LCAX4-14F-L
Copper Lug - One-Hole, Standard Flex Barrel, 90° Angle Tongue

SCALE N/A DRAWING NO / CAD FILE LCAX4-14F-CUST

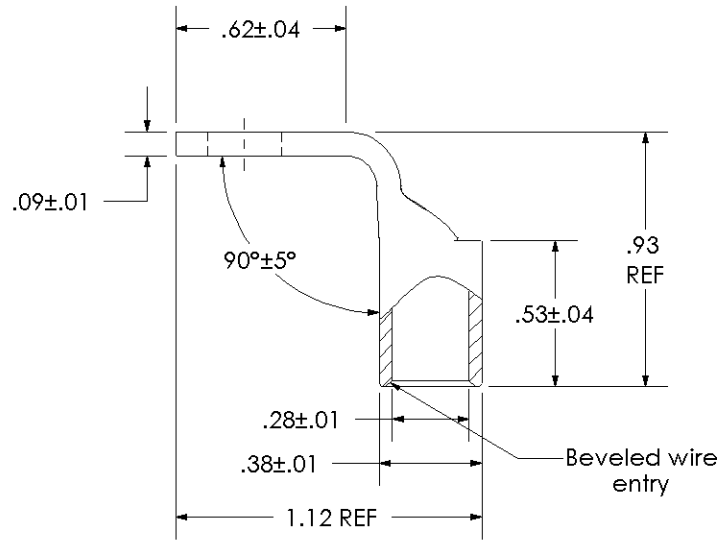
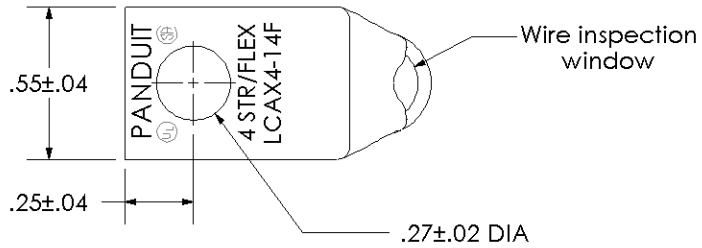
01	3/04	KLFU	TLCO	WIRE SIZE WAS: 4 STR/FLEX ADDED 3 & 5 FLEX, LOCOMOTIVE ONLY * NOTE	11610
REV	DATE	BY	CHK	DESCRIPTION	ECN
